METROPOLITAN AREA PLANNING
DEPARTMENT

Re: S/D 91-66 (Preliminary Plat) Conquest North Addition

CASE NUMBER: S/D 91-66 - CONQUEST NORTH ADDITION

FINAL PLAT CONQUEST NORTH ADDITION

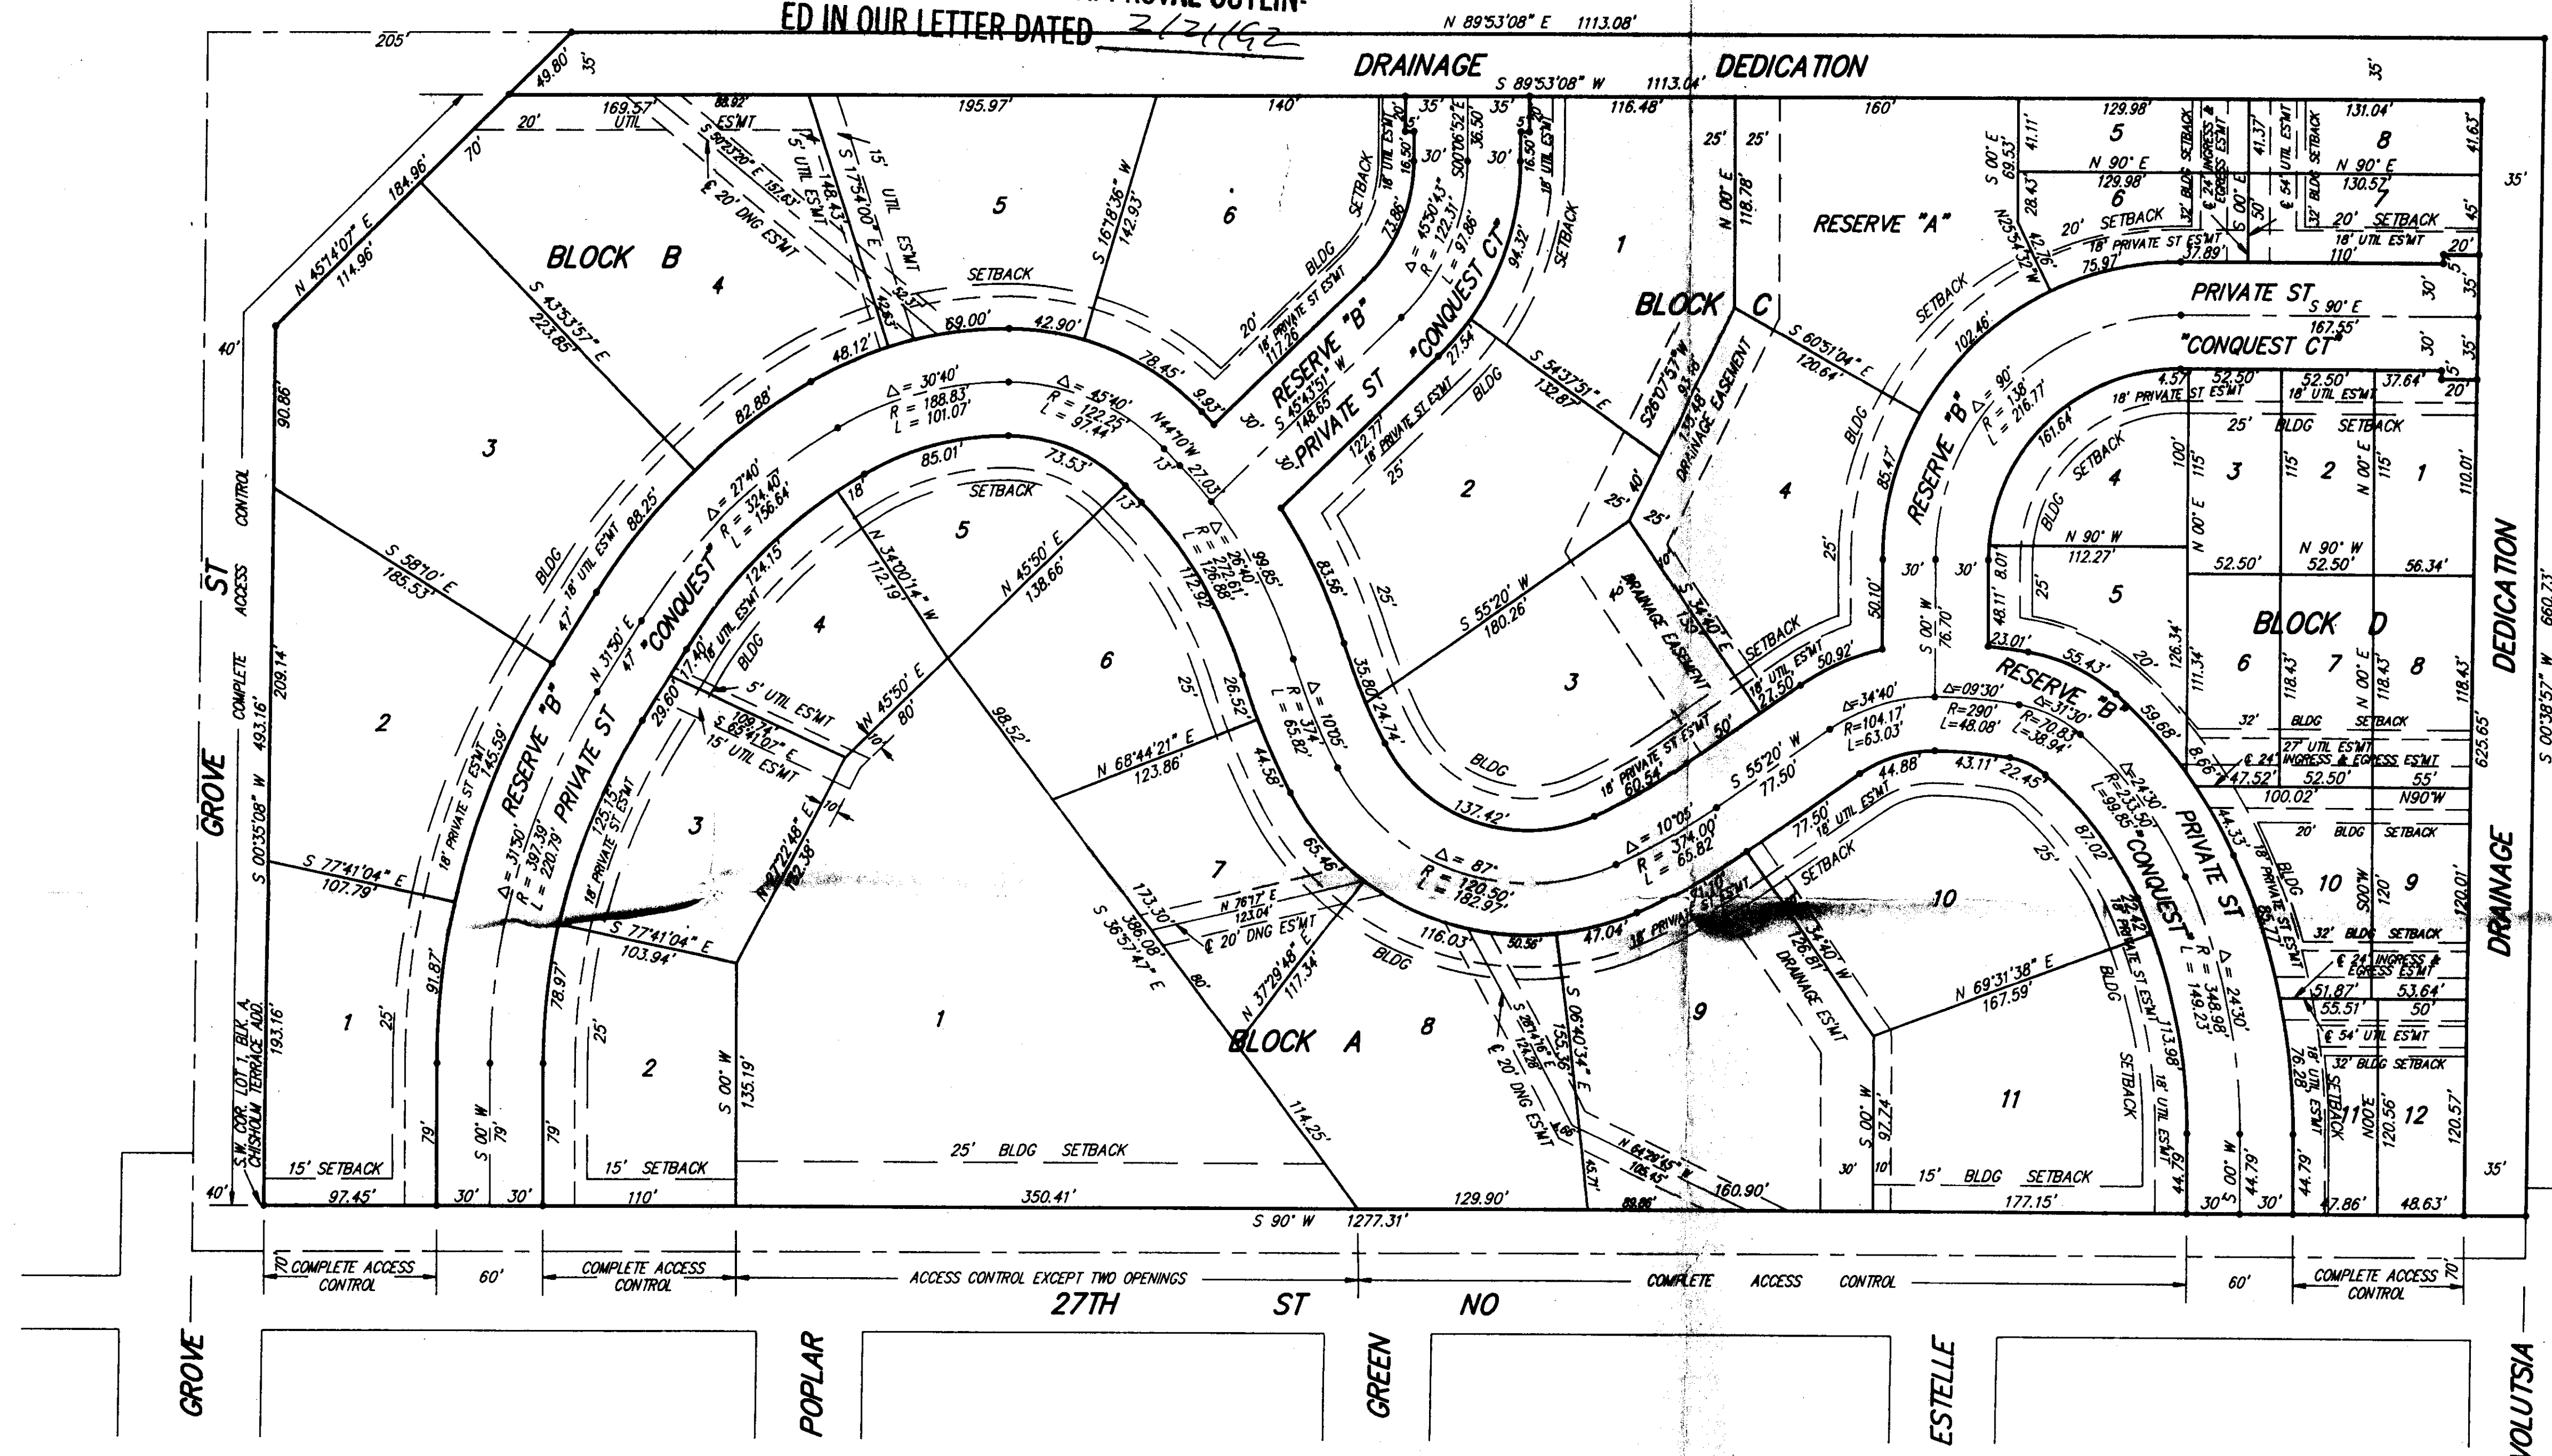
- A. In order to provide for the type of development now being proposed for this site and to specifically change the use to single family, and allow for the unconventional lots platted in the eastern portion of this site, the applicant shall pursue an adjustment to the current CUP, DP-24. Since this site involves both existing nonstandard type streets and is proposing other non-conventional access to certain of the platted lots (24 foot ingress-egress easements), the CUP should be the means to establish a private street system. The final plat shall not be submitted until the CUP is adjusted.

- B. The present street system was constructed with a 24 foot driving surface with 90 degree paved parking areas provided in front of the apartment structures. As required by City Engineering, guarantees will be provided to reconstruct or repair this street system to a public paving standard.

- D. The applicant shall submit a covenant which provides for four (4) off-street parking spaces per dwelling unit on each lot which abuts a narrow street. The covenant shall inventory the affected lots by lot and block number and shall state that the covenant runs with the land and is binding on future owners and assigns.

- F. Although an existing sanitary sewer system was provided for the previous development, certain lots being created by this plat will not have direct access to a sewer line. Further, the existing line is now and may continue to be located under street pavement which is generally not considered as allowing an abutting property to have proper access to the sewer line. Sewer shall be extended and provided for each lot prior to the paving reconstruction required in Comment "B".

- L. Since lots 8 and 9, Block A involve double frontage with access intended from Conquest St., the final plat shall indicate complete access control across these lots' south lines to 27th St. North. Similarly, complete access control to Grove St. shall be indicated across the west line of lots 1, 2, and 3, Block B.

indicated on the plat. For the narrow lots in the eastern portion of this site, the platting of side yard setbacks seems to be an unnecessary restriction and may be deleted.

- R. On the final plat, in order to better locate the easements crossing lot 4, Block B and lots 8, and 9 Block A dimensions shall be shown from lot carriers to the easements.
